BODY & TRIM

MODIFICATION NOTICE

Major Modification Item

Body Mounting

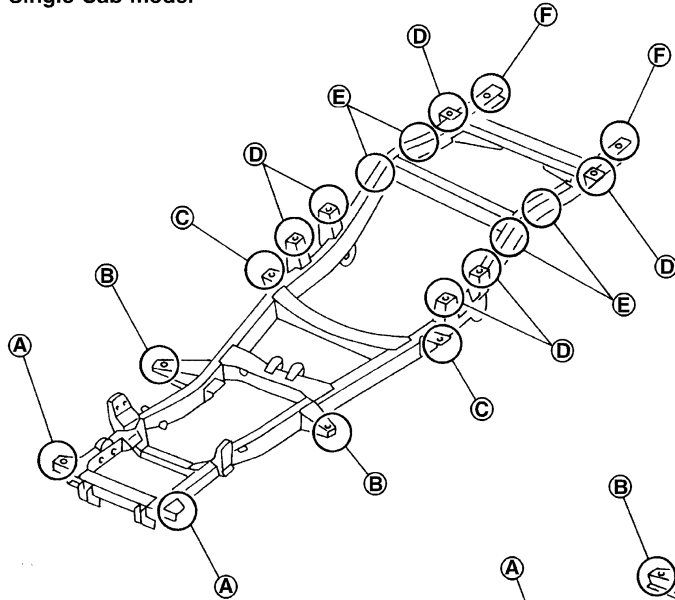
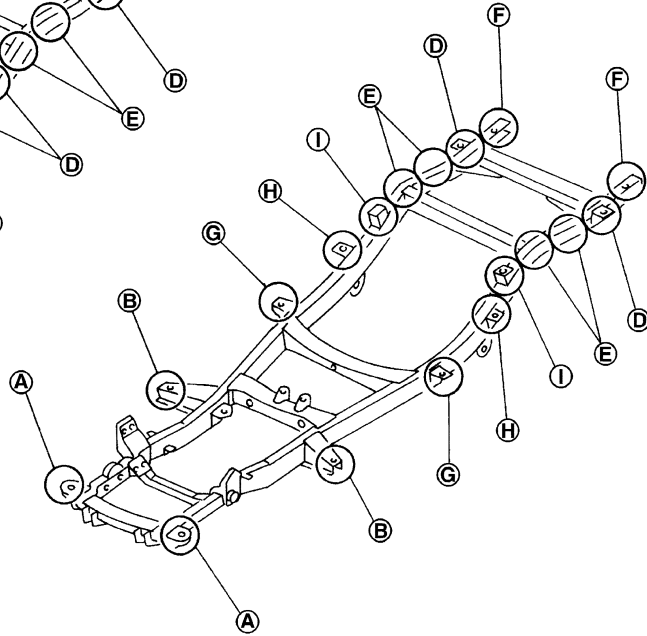
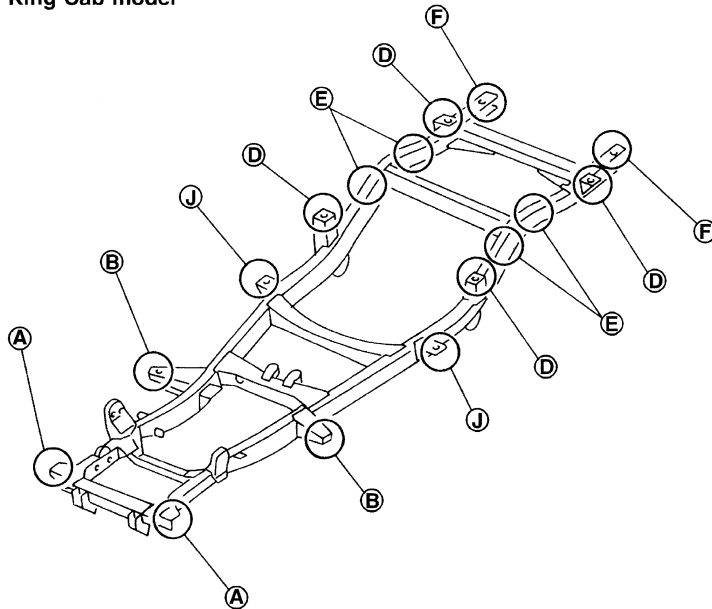
Body mounting bolts tightening torque have been change.

When removing, be sure to replace bolts and nuts (sealant applied bolts or self-lock nuts are used for all mounting).
